**WEIRTON SANITARY BOARD  
BROOKE COUNTY, WEST VIRGINIA**

**CONTRACT #1 – WASTEWATER TREATMENT PLANT UPGRADE**

**ADDENDUM #2**

**THRASHER PROJECT #020-01649**

SHEET No.
<b>10A</b>

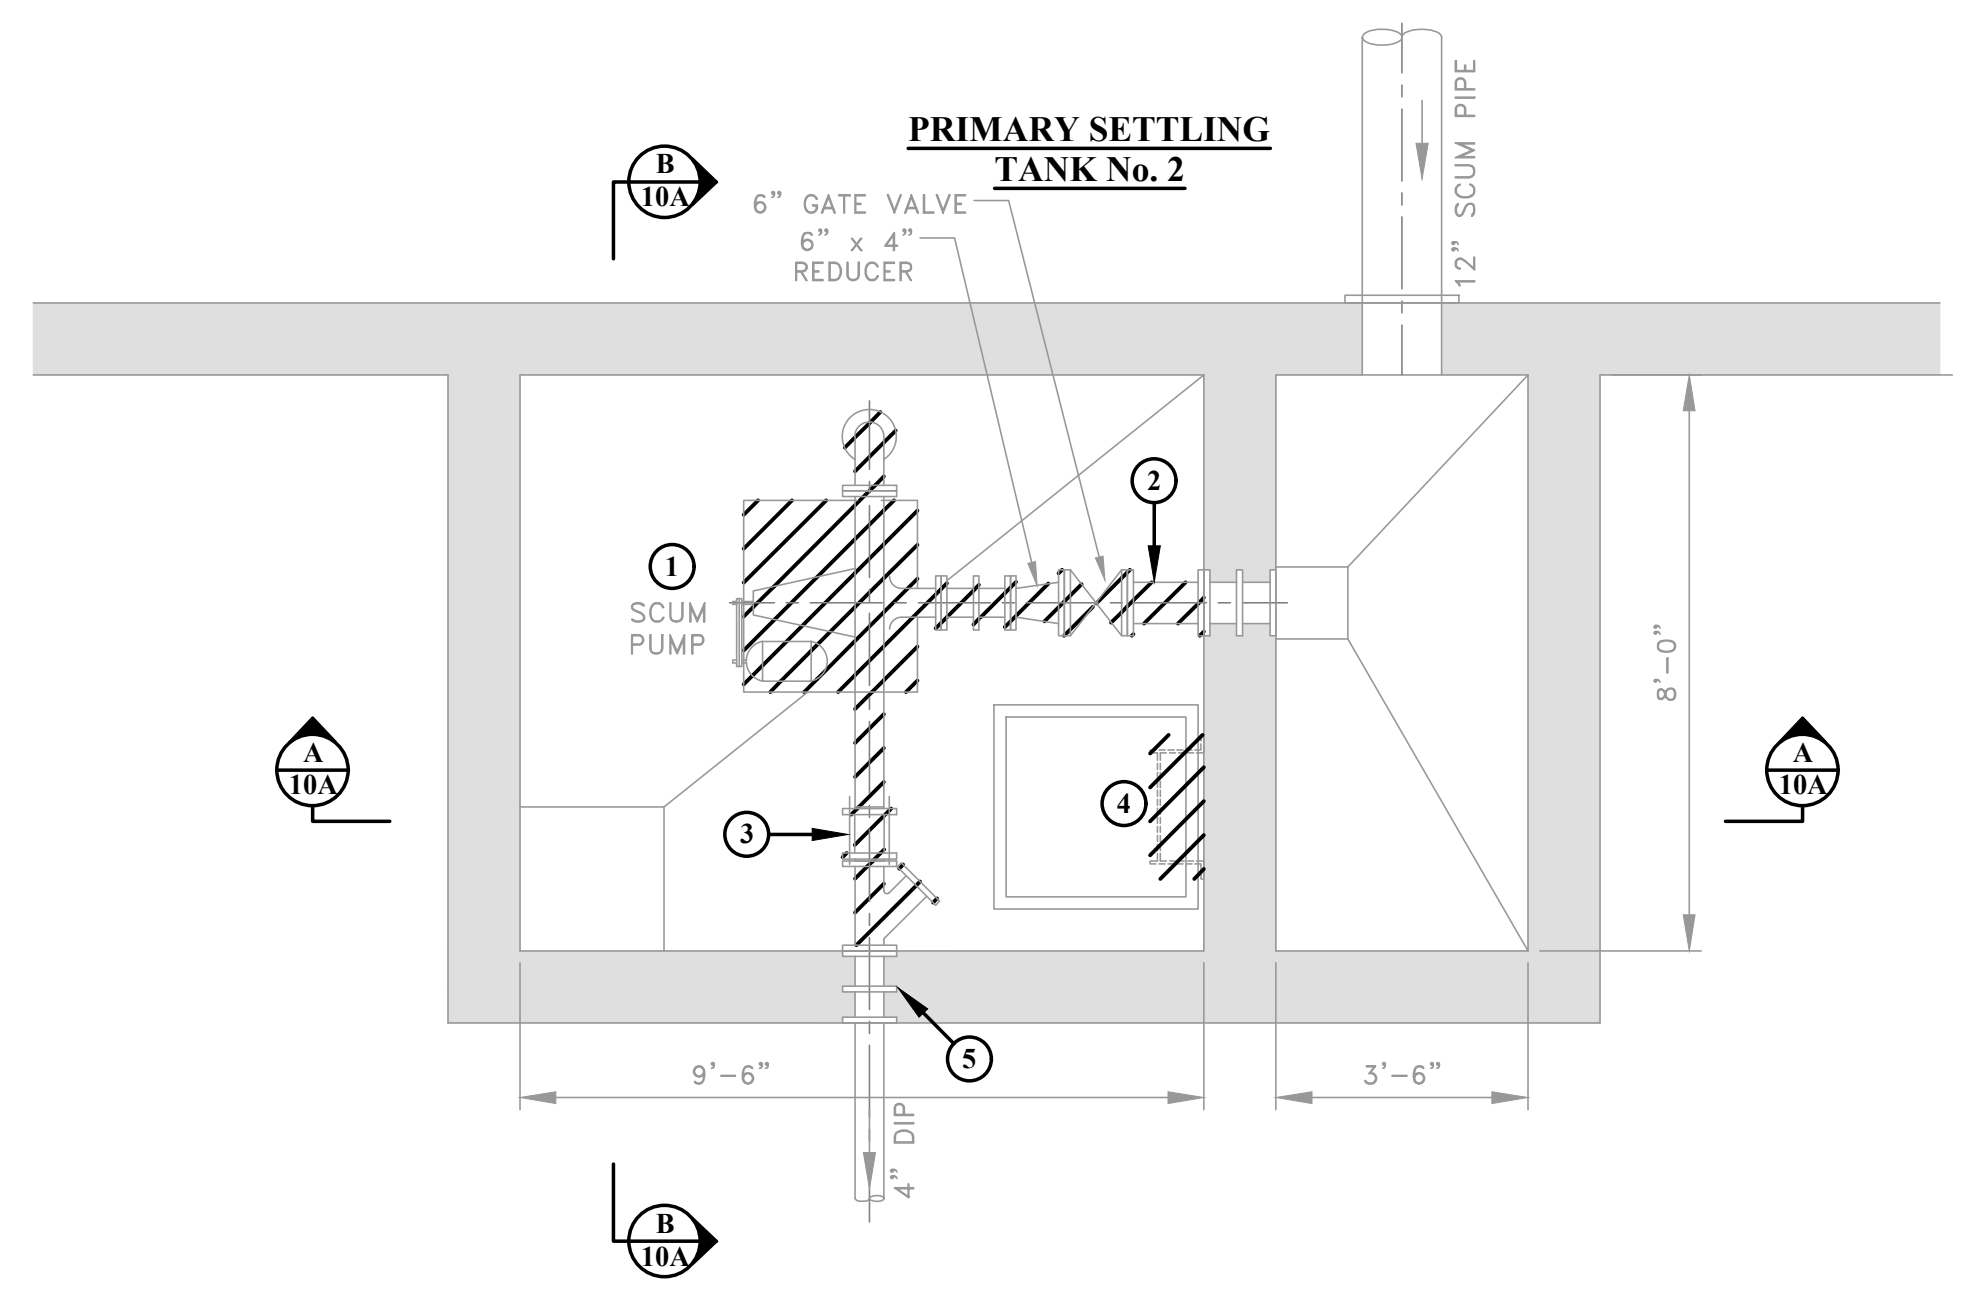
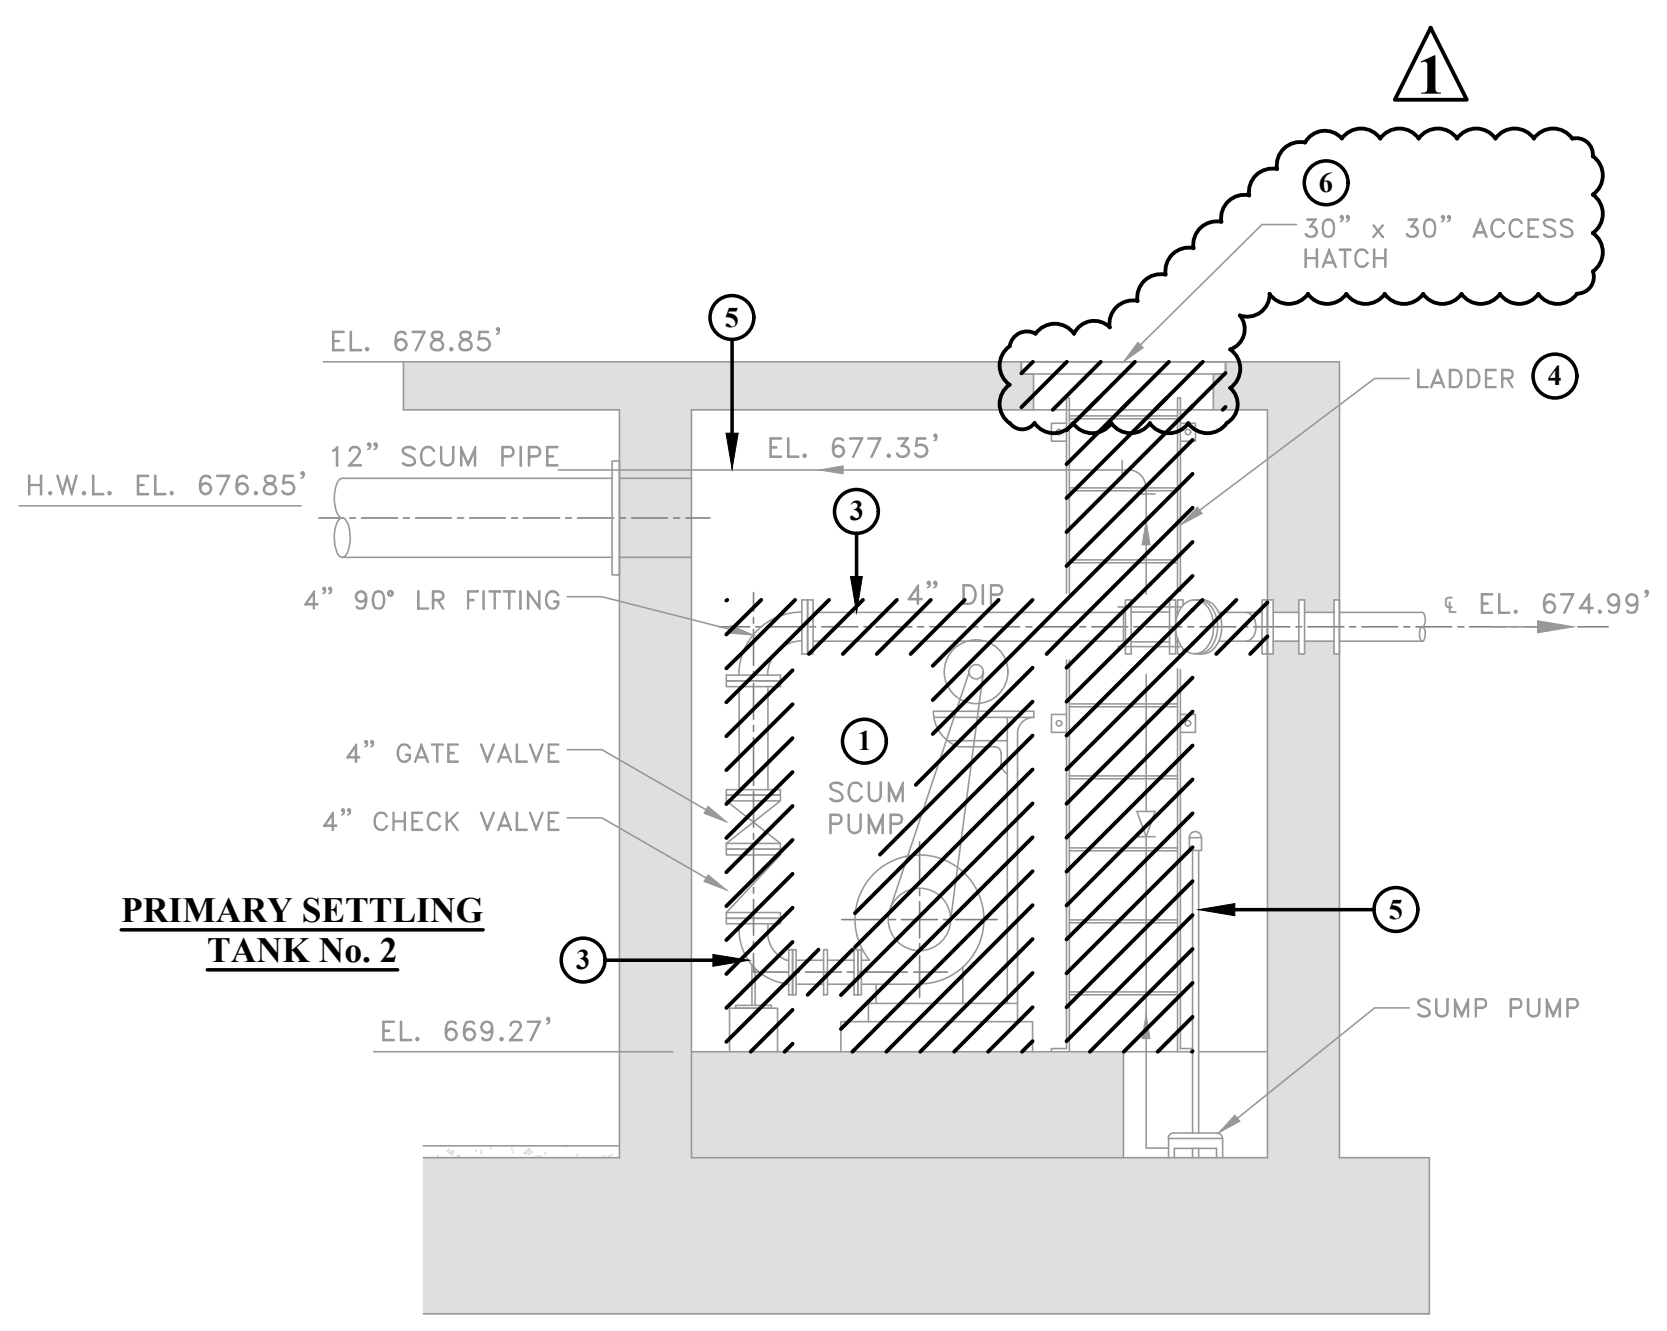
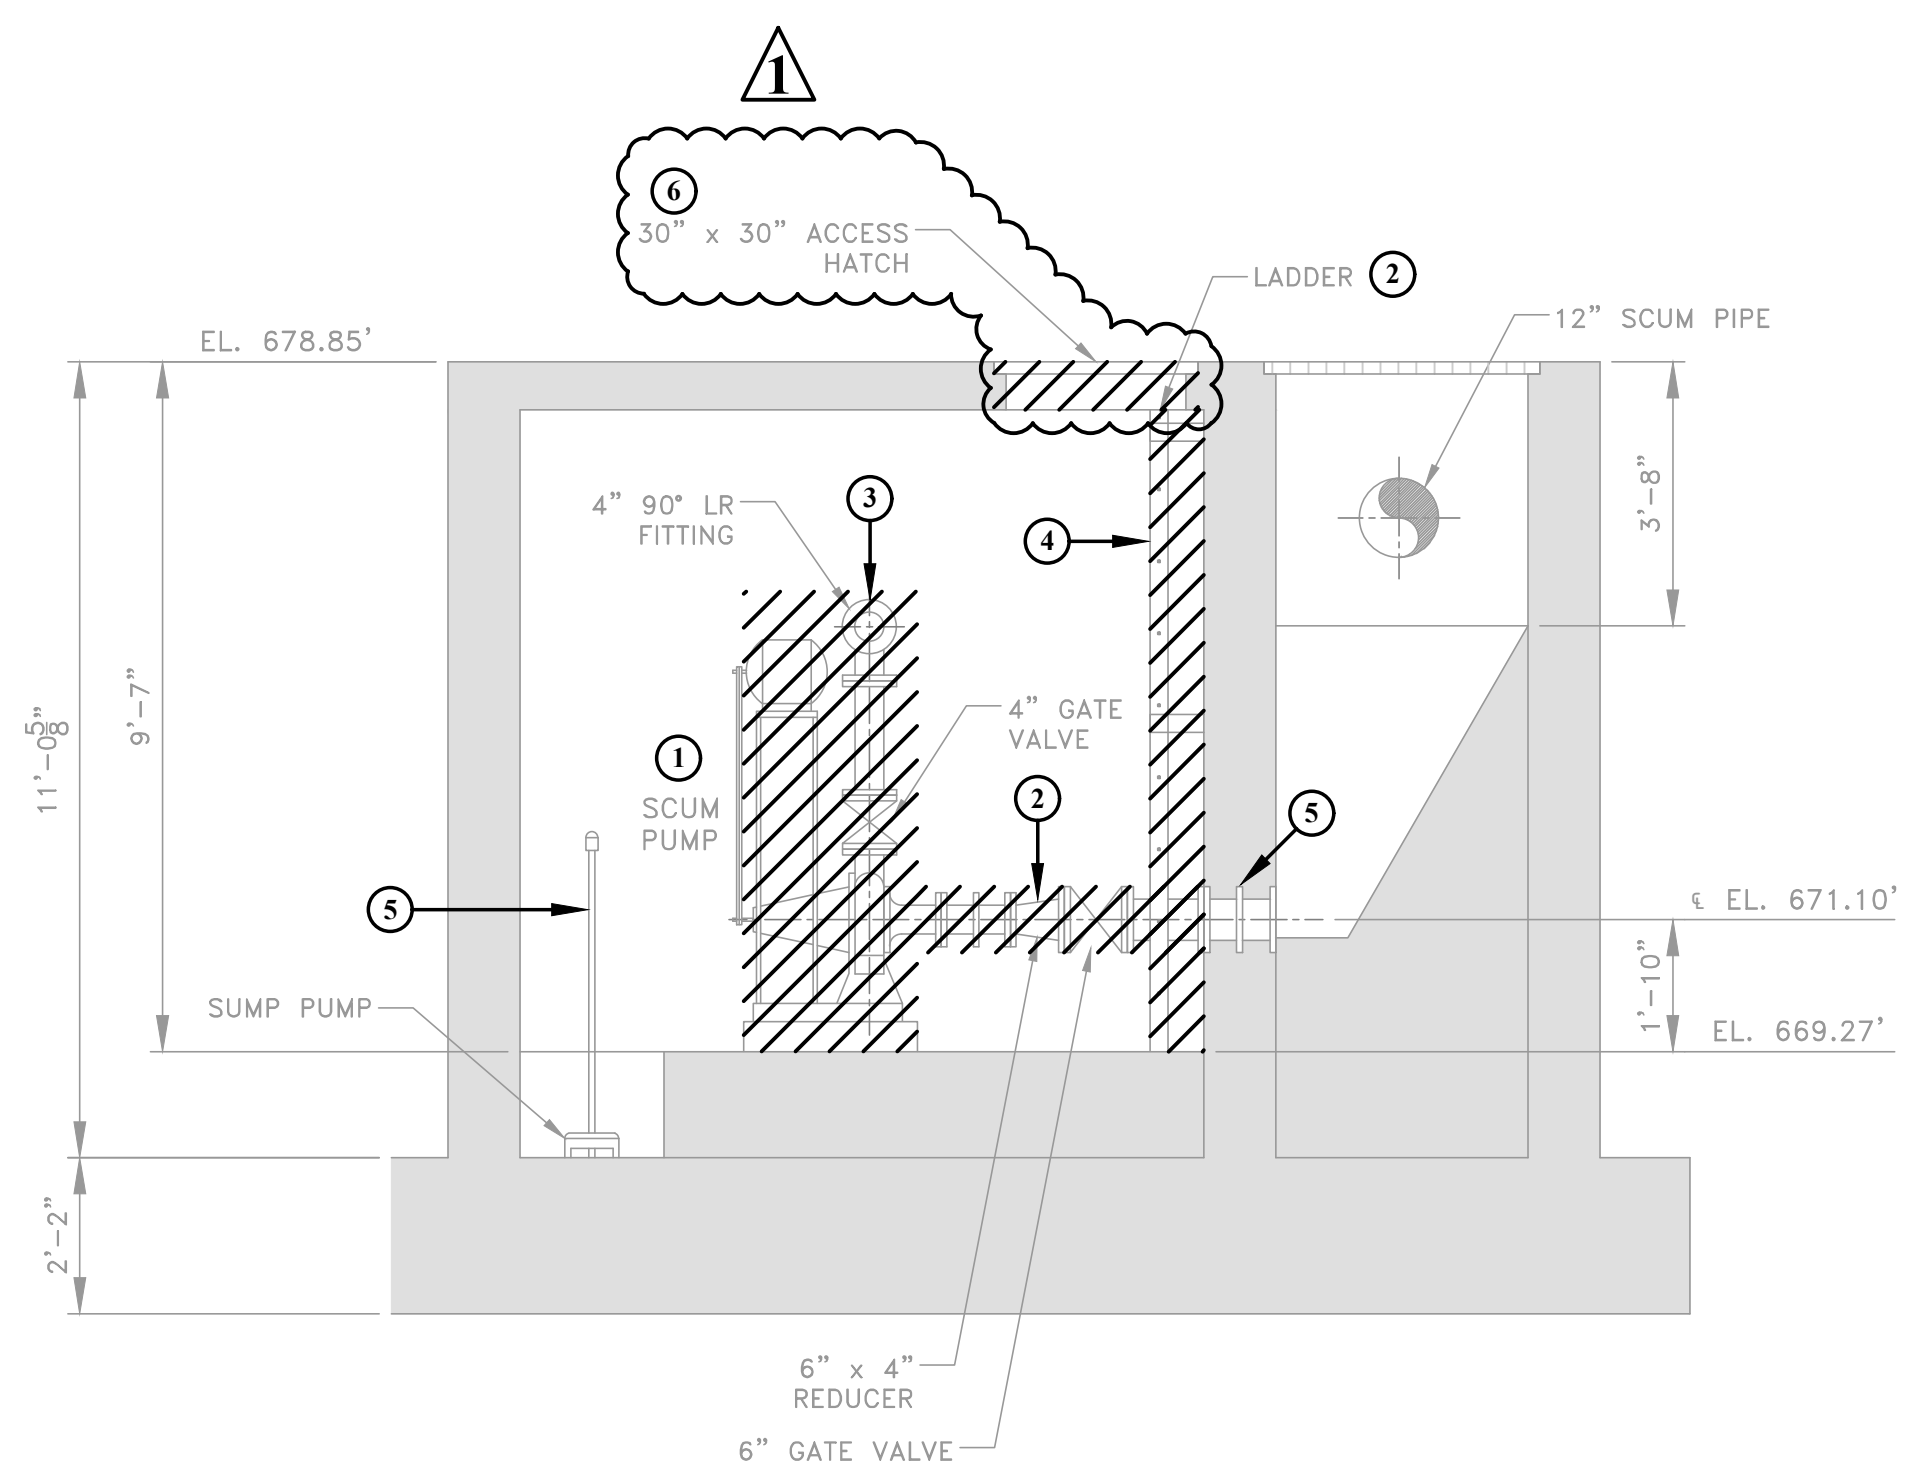
NO.	BY	DATE	DESCRIPTION
1	JLA	10/25/23	ADDENDUM No.2 - REMOVE ACCESS HATCH
